## DEPARTMENT OF DEVELOPMENT SERVICES – PLANNING DIVISION

*REPORT:* Inland Wetlands & Watercourses Permit, MDC SHCST, 611 Brookfield St. and 180 John D. Wardlaw Way  
for consideration April 27, 2021

### STAFF REPORT

**PROJECT INFO:** Application for Inland Wetlands & Watercourses Permit at  
1) 611 Brookfield St., Parcel ID 140-588-004,  
Property Owner: The Metropolitan District Commission  
2) 180 John D. Wardlaw Way, Parcel ID 140-588-003,  
Property Owner: City of Hartford Housing Authority

Figure 2. Map of Slurry Deposition Area from the Wetlands Report.

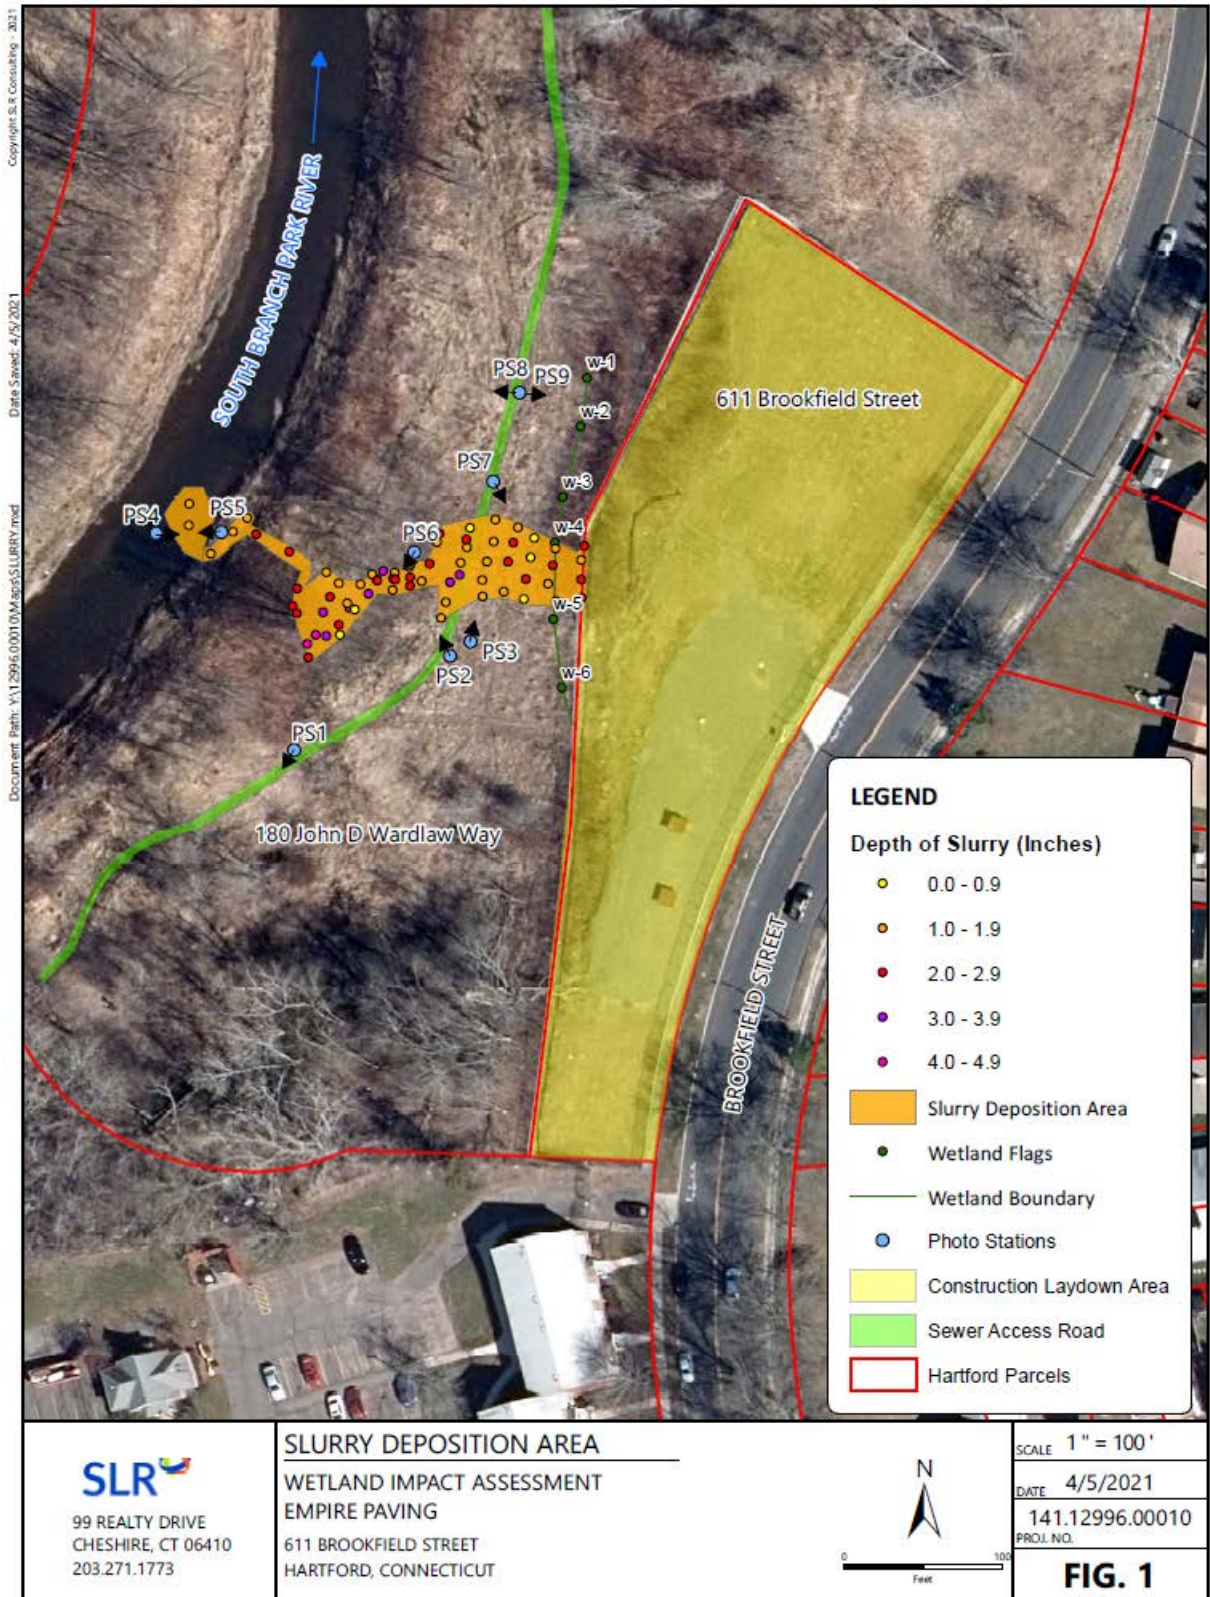
- The area of slurry deposition within the wetland and watercourse is approximately 4,710 sq. ft. (see Figure 2), including:
    - 4,140 sq. ft. of slope and floodplain wetland; and

- It is recommended that the slurry be strategically removed, disturbed areas seeded, sediment & erosion controls installed, followed by post-restoration monitoring of the advancement of natural vegetation recovery (p.1).

## STAGING PLANS FOR DROP SHAFT DS-2 AND MICROTUNNEL SHAFT AT ACP JUNCTION MANHOLE

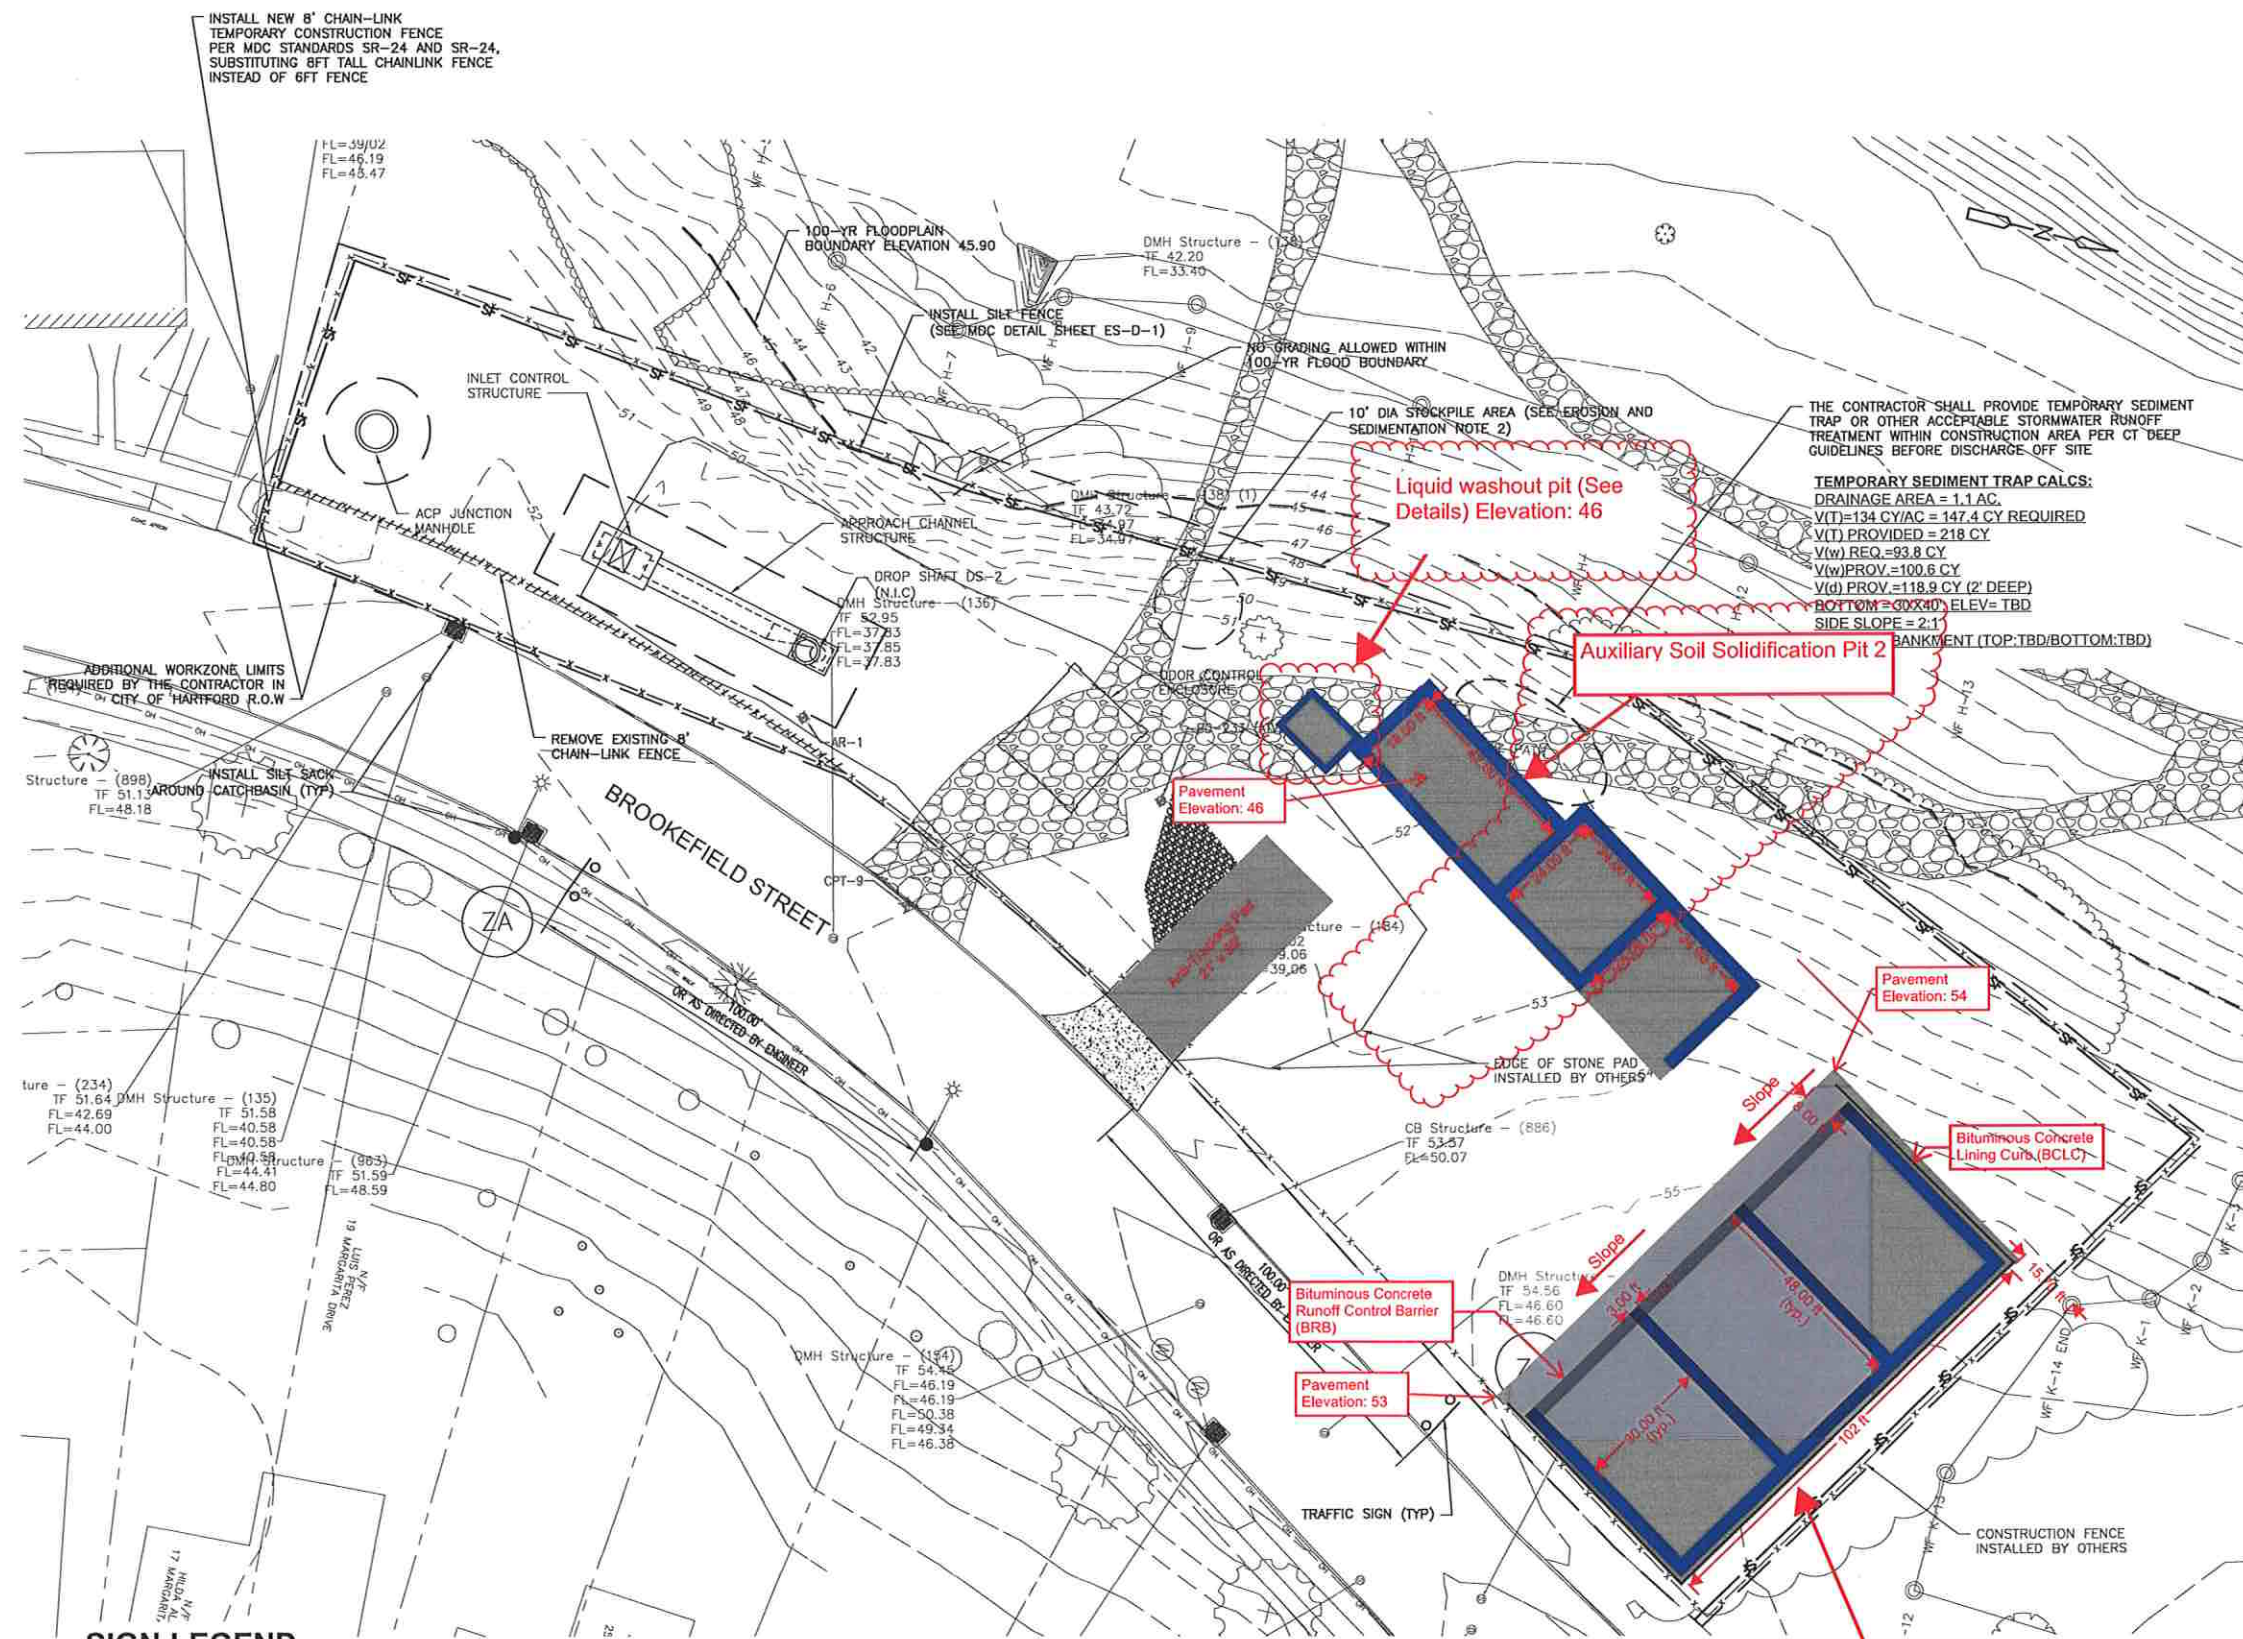
- Extend the current haybale barrier inside the current/older silt fence, to extend further to the east along the north fence line behind the Soil Solidification Pit, with your suggested comment of an additional silt fence (as primary sediment barrier) just inside this haybale barrier serving secondary buffer wall.
- Silt fence repairs in the north corner fence line to the north of the WSA bins.
